**ADDENDUM NO. 1**

July 16, 2021

**THE CITY OF GREENVILLE, NC  
NEW FIRE / RESCUE STATION NO. 7  
4176 BAYSWATER ROAD, WINTERVILLE, NC 28590  
ARCHITECTS PROJECT NO. 1658**

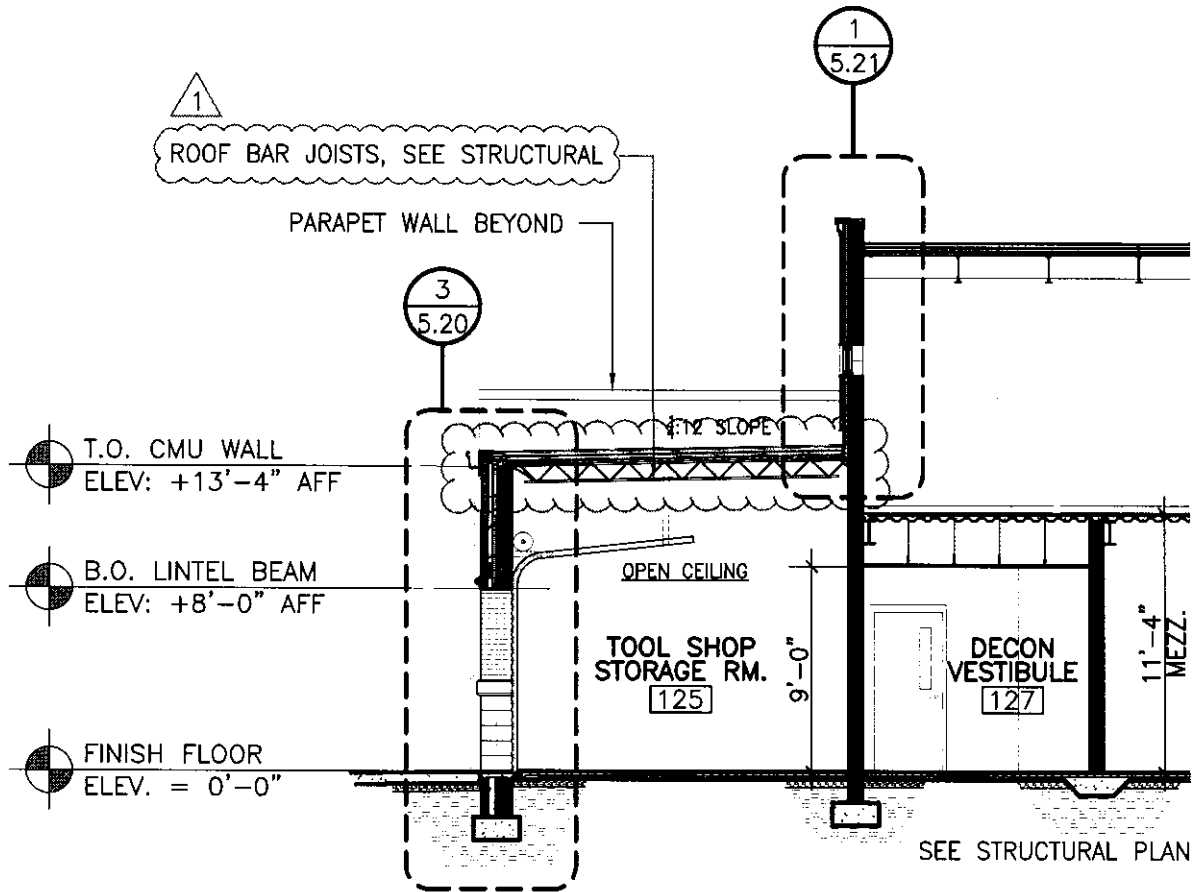
- ABD-1** Updates provided for drawing sheet 7.21 detail #4.
- ABD-2** Updates provided for drawing sheet 5.23 detail #12.
- ABD-3** Revised building section for drawing sheet 5.12 detail #2.
- ABD-4** Revised detail #6 for drawing sheet 5.25.
- ABD-5** Revised building section tag drawing sheet 4.11.
- ABD-6** Revised finish tag description’s for drawing sheet 7.10.
- ABD-7** Revised detail #8 for drawing sheet 5.30.

REFERENCE SHEET NO. 7.10

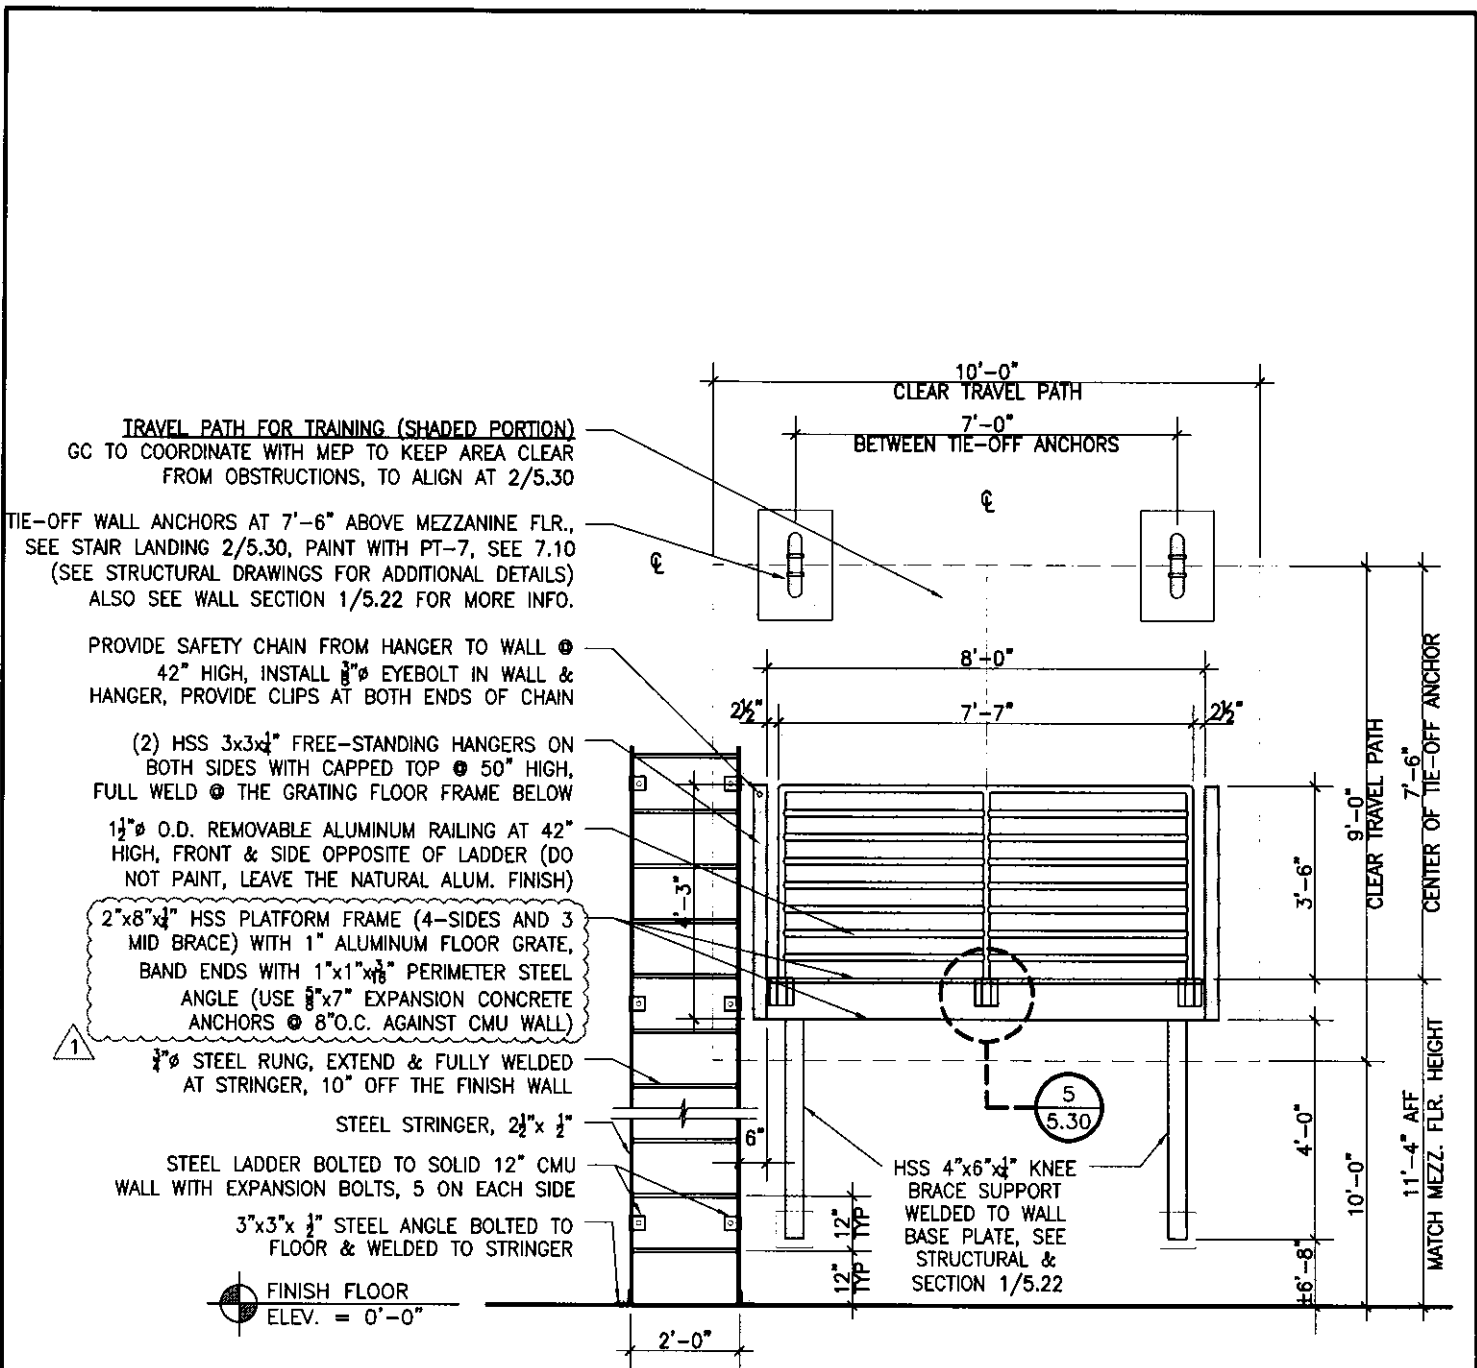
REVISED FINISH TAG DESCRIPTIONS FOR PCF and WT-2.

**WT-2** WINDOW TREATMENT (SEE 1/7.10 PLAN FOR LOCATIONS), LEAD FREE FABRIC, ECOFABRIX 255 SERIES, 5% OPENNESS FACTOR, MANUAL BLACKOUT ROLLER SHADE, -89 GREY/BLACK, DIRECT MOUNT WITH SEALED HEM BAR.

Sheet No. **S3.15**

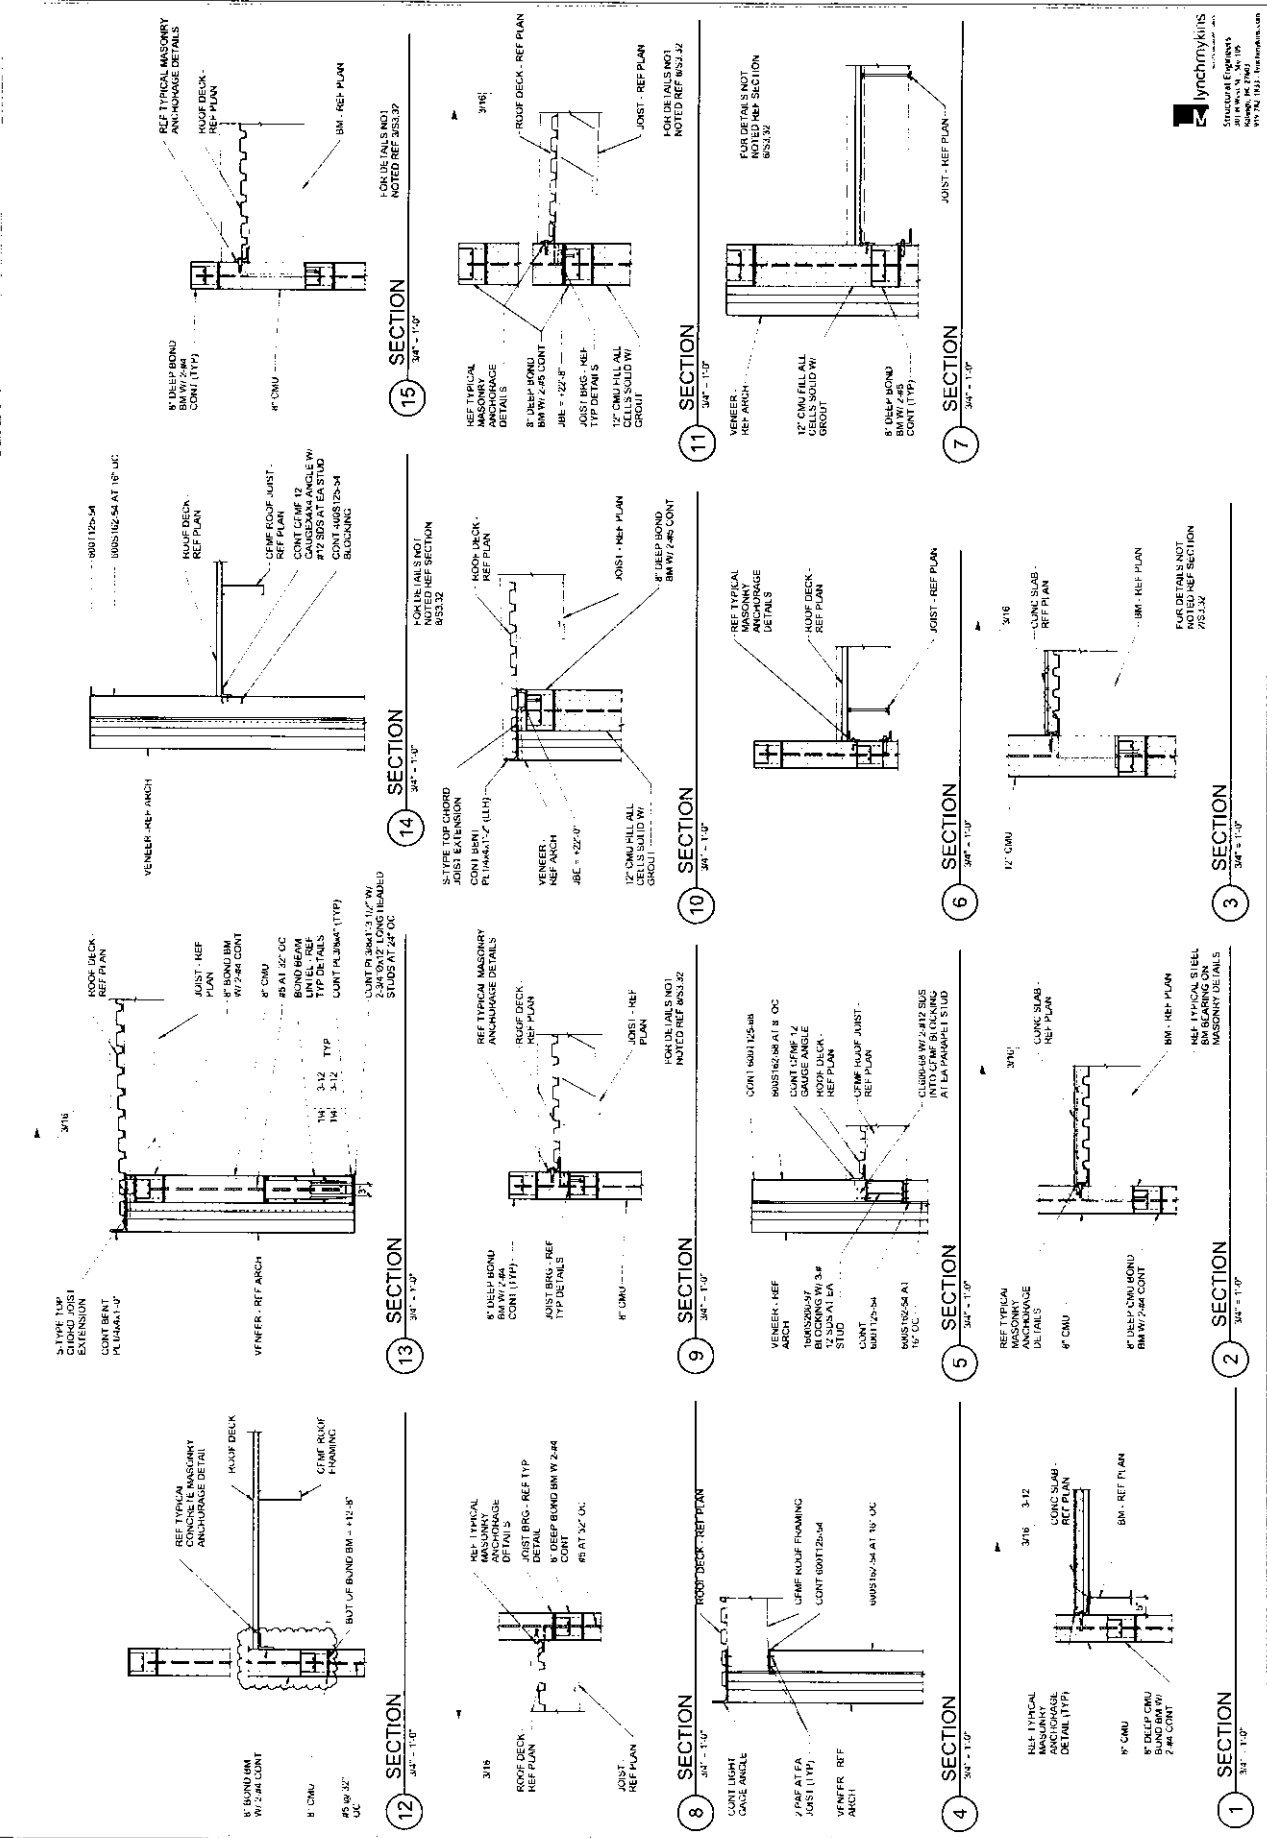
See revisions marked on the following new drawing sheets.

**Drawing Sheets - S3.02, S3.11, S3.12, S3.13, S3.14, S3.15, S3.21, S3.31, S3.32, S3.33, S3.55,**
